# Service Bulletin

Bulletin No.: PIT5307A

**Subject:** SES MIL / Service Suspension System / ABS MIL / No Crank (Inspect Engine Harness Chaffing At Vacuum Pump Pulley)

**Models:** 2015 Cadillac Escalade Models  
 2014 Chevrolet Silverado 1500  
 2015 Chevrolet Silverado 1500, Suburban, Tahoe  
 2014 GMC Sierra 1500  
 2015 GMC Sierra 1500, Yukon Models  
 With 5.3L (RPO L83) or 6.2L (RPO L86) Engine

3958681

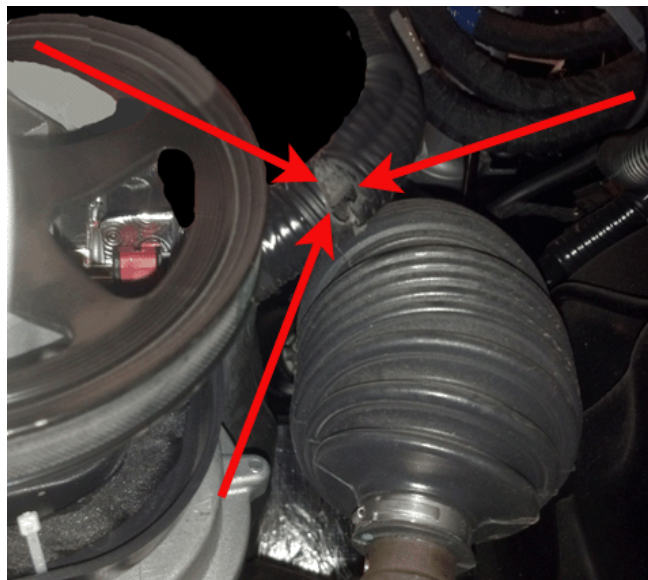
Some owners may comment on any of the following issues: SES MIL, ABS MIL, Service Suspension System Message, no crank caused by the "STRTR" fuse 11 (F11UA) open, as well as any combination of the following DTCs may be found: C0035, C0040, C0575, C0580, C0615, C0620, C0625, C0630, C0696, P06DA, P06DB, P06DC, P0325, P0327, P0328, P0330, P0332, P0333, P0340, P0341, P0335, P0336, P0641, P0011, P0010, P2088, and/or P2089.

These issues could be caused by the engine harness rubbing on the engine vacuum pump pulley, as shown below.

Repair any damaged circuits, and re-secure the harness away from the pulley to prevent the issue from reoccurring.
